Responses to RC1:

This manuscript presents the calibration algorithms used for the ACDL lidar onboard the DQ-1 satellite, with the analysis of the 532 nm nighttime polarization and high-spectral-resolution channels. This work is of interest to the lidar community. Also, the upcoming launch of EarthCARE with the ATLID lidar in May 2024 will provide opportunity for further comparative studies between these two advanced lidar systems. I appreciate the efforts made in this study and offer some comments for improvement of this manuscript. Additionally, a careful review of the manuscript for English language improvements is advised, as some sections may benefit from further editing for clarity and grammatical accuracy.

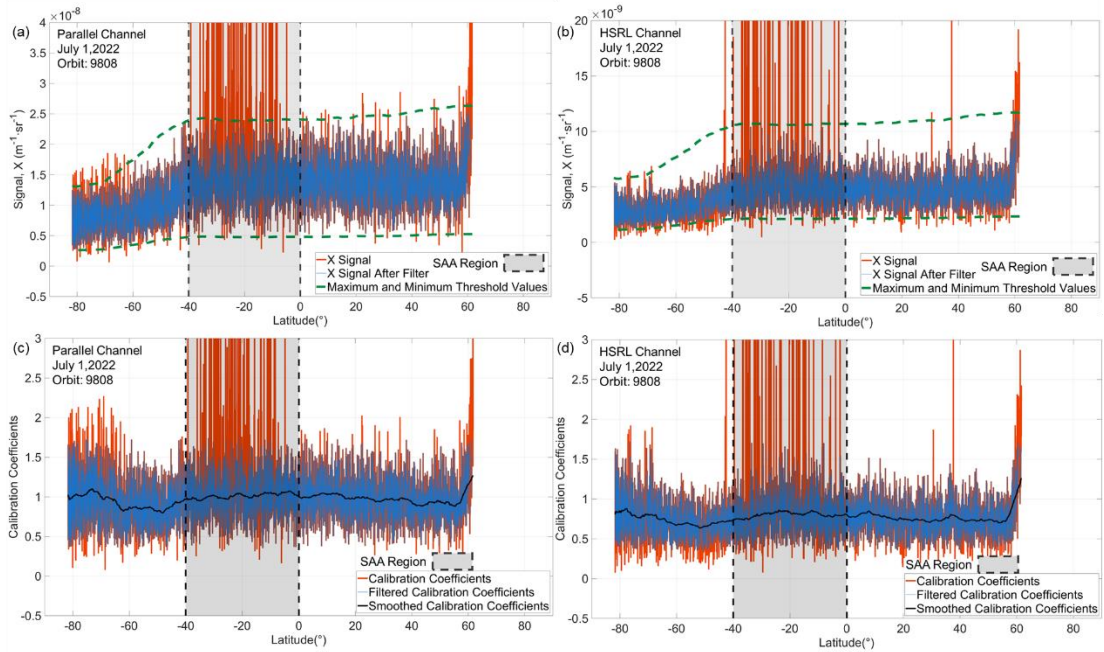
2. Figure 7 (a): The large variation in original signals within the SAA region is noticeable, but the overlay of filtered signals obscures the original data in most other regions. Adjusting the transparency level of the filtered data may resolve this issue. This recommendation applies to all subplots in Figure 7.

- Figure 7 (c): There appears to be a discrepancy in the upper left legend; it likely should be labeled as “Parallel Channel” rather than “HSRL channel.”

Figure 7: The subfigure labels (a)(b)(c)(d) are missing or unclear.

AR: Thanks for the suggestion. The figure 7 has been reprocessed by changing the line color of the original signal to orange and bold, adjusting color of the filtered data to blue and change the transparency.

AR: We feel sorry for our carelessness. In our resubmitted manuscript, the figure is revised.

AR: Thanks, revised.

Signal distribution and filtering scheme for 33 km (Orbit 9808)

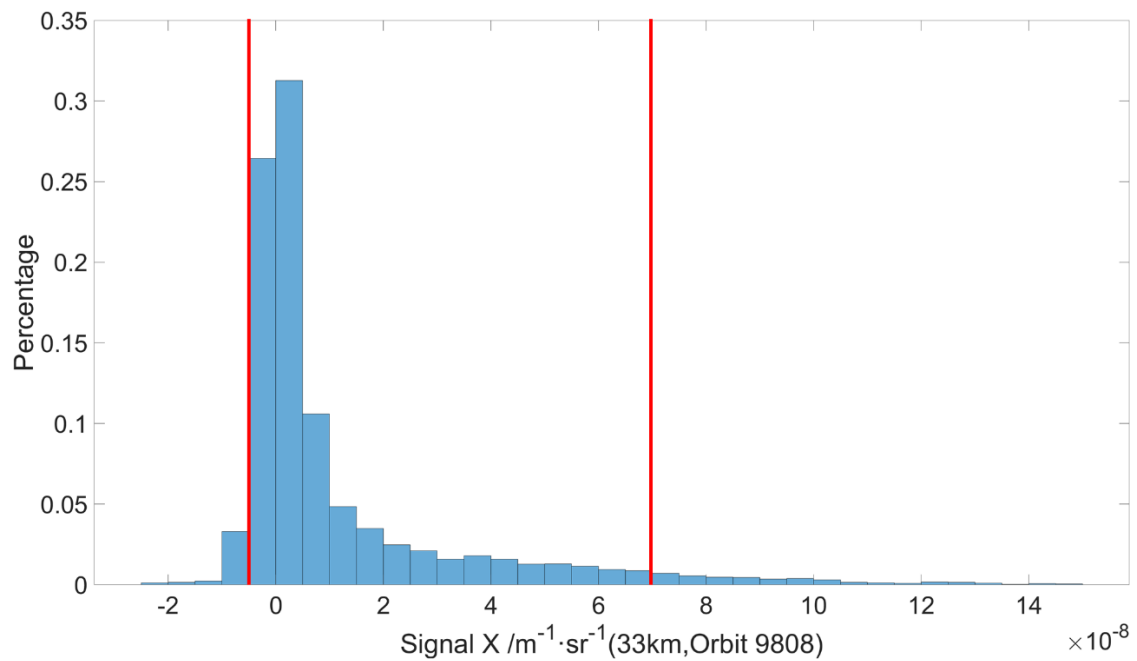
Line 289: Please provide details on defining the empirical scaling factor k_m , including the specific factor used in this study.

AR: Thanks for pointing these issues. We performed a statistical analysis of the signal intensity distribution of signals (as shown in the figure below). The intensity of signal distributions that are significantly higher (or lower) than the measured values are used as the basis for selecting the scaling factors. In this research, the scale factors are chosen as -0.5 and 1.5.

Line 321: The selection of the scaling factor is based on the statistical analysis of the signal intensity distribution of the high-energy signals, Since the ACDL signal basically follows the Poisson distribution, with drastic changes in the low value region and smoothness in the high value region, different factors are selected in the high and low value regions to ensure the accuracy of the data. Therefore, in this study, the scaling factors were chosen to be asymmetrical -0.5 and 1.5.
